SERVICE BULLETIN

Service Bulletin No.: DA20-32-05 Rev. 3

Title: Replacement of Steel MLG Struts
with Aluminum MLG Struts

Figure 1 - Aluminum Main Landing Gear - Strut Installation

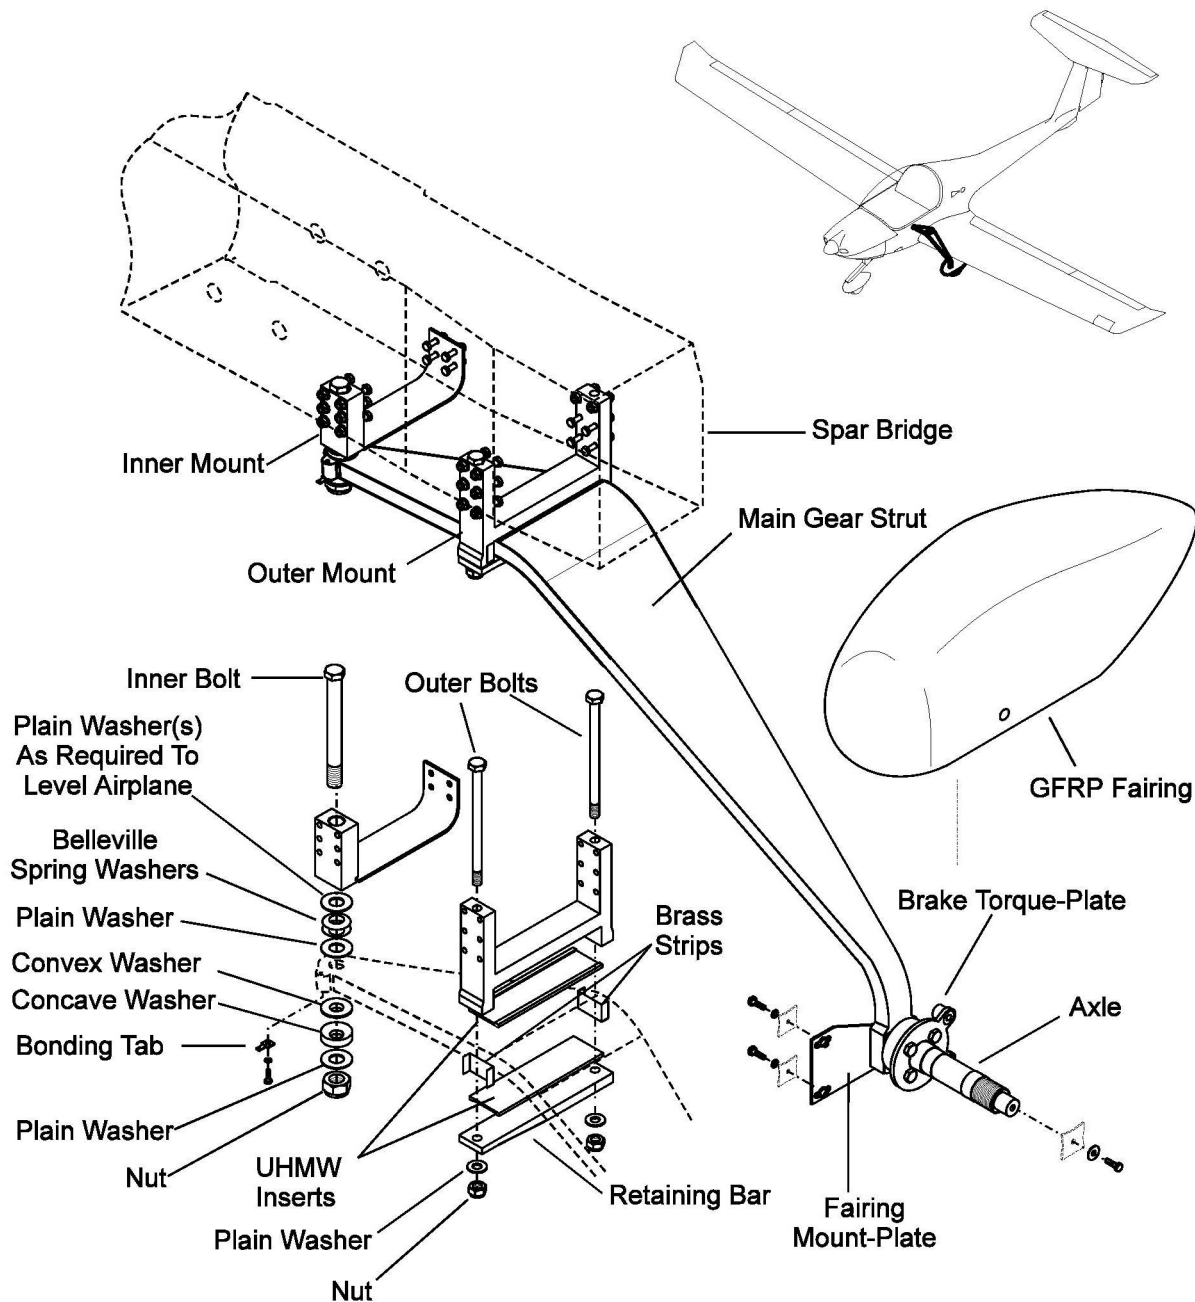
- 10.1 Put the aircraft on jacks. Refer to AMM # DA201-A1 Chapter 07-20.
- 10.2 Remove the steel MLG strut (P/N 20-3210-00-01) LH and the steel MLG strut (P/N 20-3210-00-02) RH.
Refer to AMM # DA201-A1 Chapter 32-10.
- 10.3 Install the aluminum MLG strut (P/N 22-3211-00-01) LH.
Refer to Figure 1, Figure 2, and the Parts Listing for the aluminum MLG.
 - 10.3.1 Examine the spar bridge in the area of the main gear mounting locations.
Look specifically for damage to the GFRP structure.
Refer to AMM # DA201-A1 Chapter 51-10 for GFRP inspection procedures.
 - 10.3.2 Put the new strut in position.

Figure 2, Sheet 1 - Aluminum Main Landing Gear

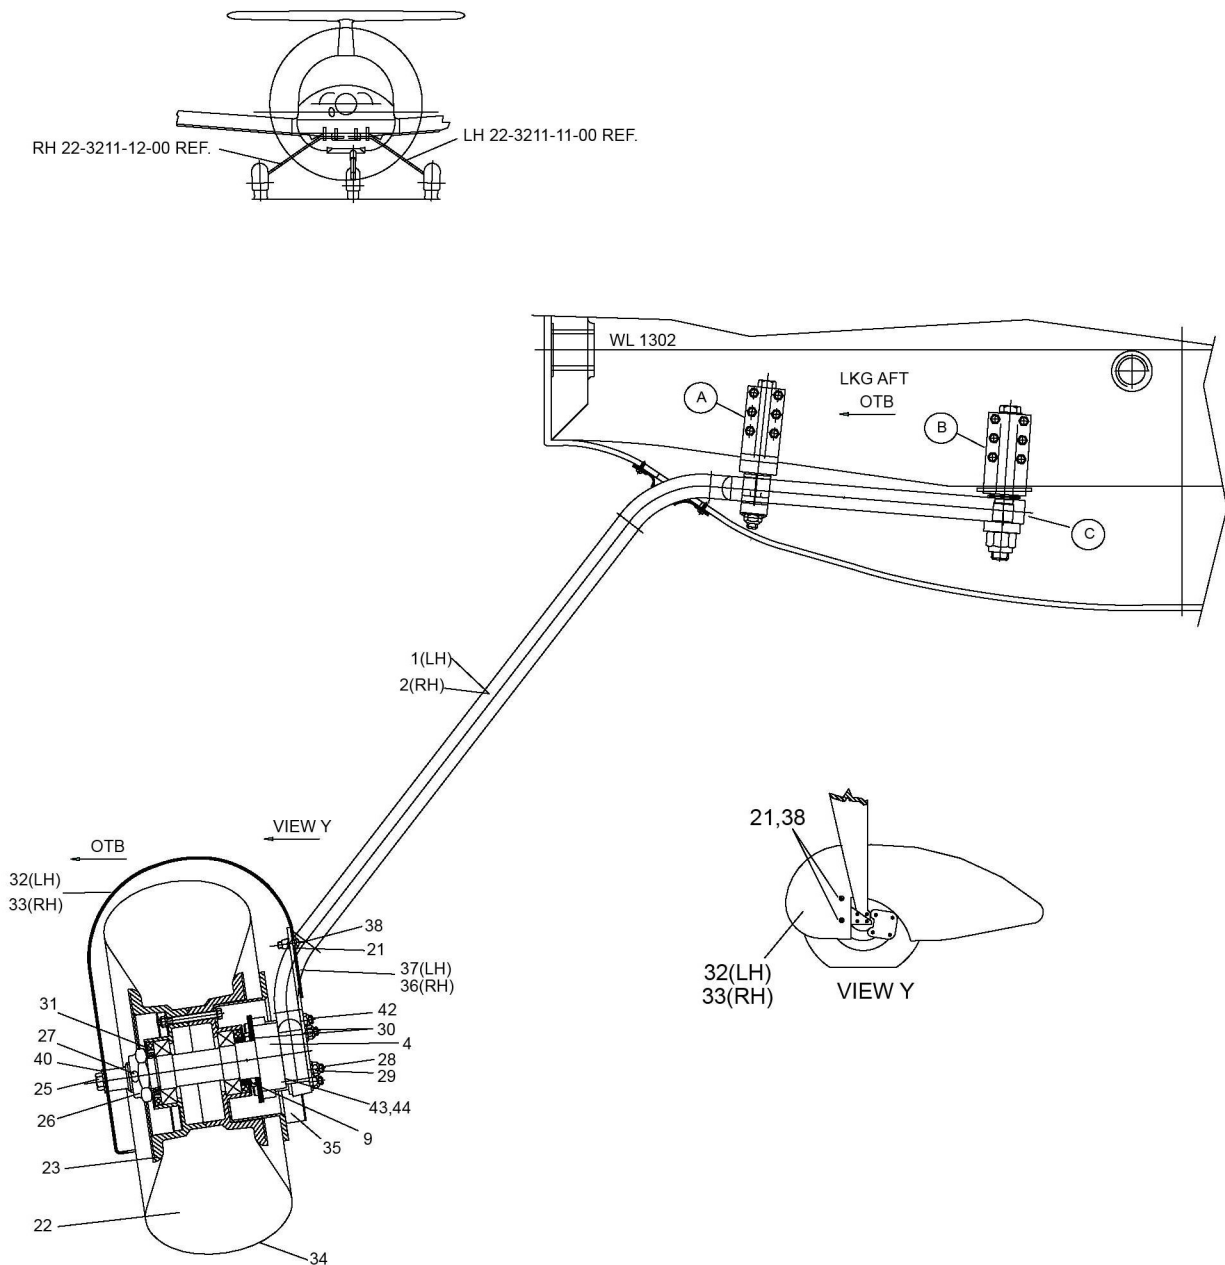
Revision 1 changes items 43 and 44 in the Parts Listing to be measured in degrees rather than inches and removes Item 45 (20-3210-10-00 - Dust, Boot Assembly) from Figure 2, Sheet 1 and the Parts Listing. The Dust, Boot Assembly can be re-used.
